During the detail design process, it has become necessary to review aspects of the approved Planning scheme to resolve the requirements of the environmental design, in order to create optimal learning environment, as well as taking on board the recommendations of the Designing Out Crime Officer. The required changes are described below.

Daylighting Assessment – Typical First Floor Classroom

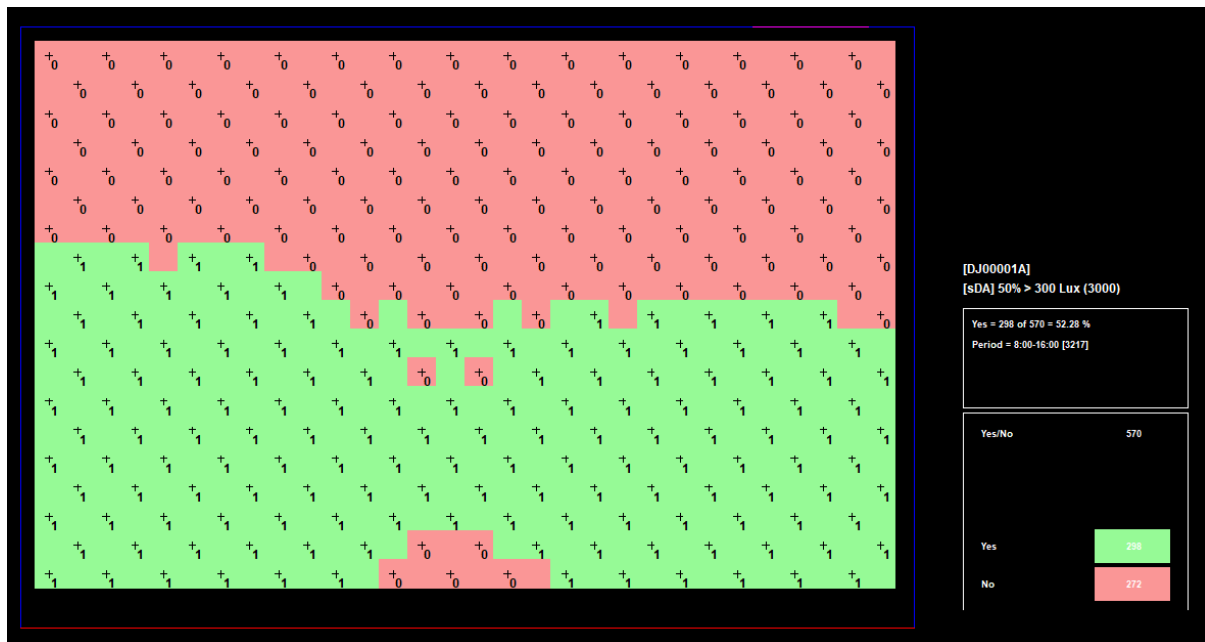
However, the First Floor Classrooms had a single large window in the corner of each classroom to achieve the 'desired' elevation treatment/balance. Unfortunately, this has significantly compromised the quality of daylighting in these classrooms and they still failed to meet the criteria by a significant margin as a result. This is shown in the daylighting diagram below – nearly 42% of the classroom meets the required criteria, however 50% compliance is required to demonstrate good practice.

As such, we have proposed to split the large windows into two smaller windows which are more evenly spaced within the room. The example shown below, demonstrates a pass under both criteria. Further details are provided with the accompanying daylighting report.

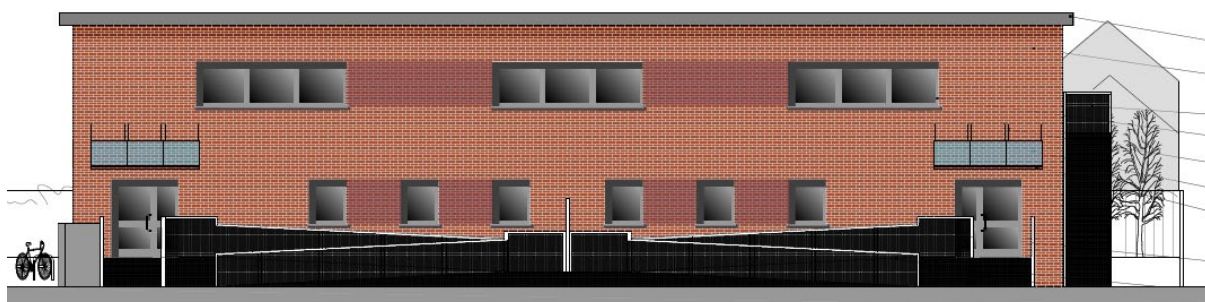
As a result of changes to the internal layout – following a strategic review by the Head Teacher – the placement of rooms at first floor is broken by the presence of a small office in the middle. The addition of a dedicated window improves the internal environment and also have a positive impact on the balance of the elevation. One external door at Ground Floor has also been replaced by a window.

*Planning Approved Scheme – Street Elevation*

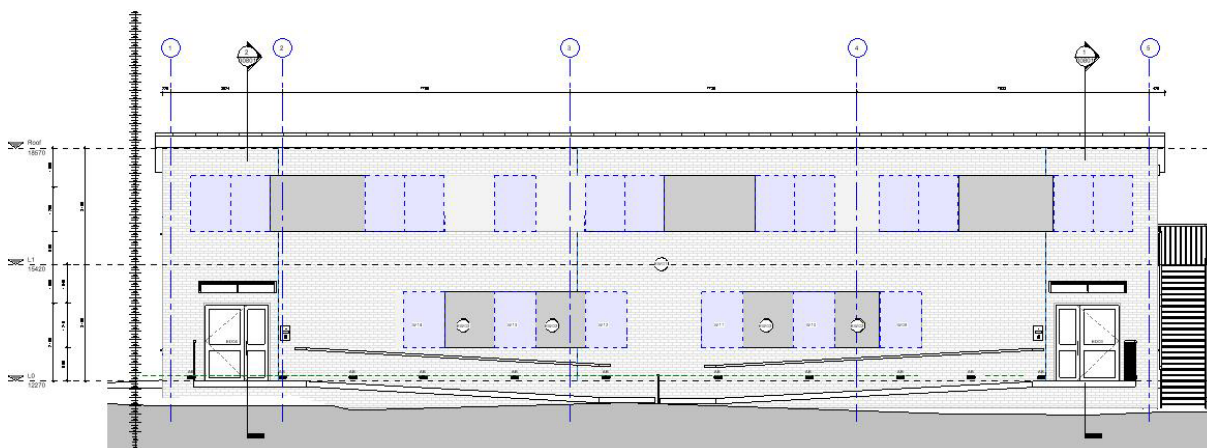
To achieve the same design principles as the original scheme, we have connected each pair of windows by special brickwork - whereas previously there were 3 large windows, all connected together. We feel this achieves the same design aesthetic, but with the significant benefit of improving the teaching environment for the school's students.
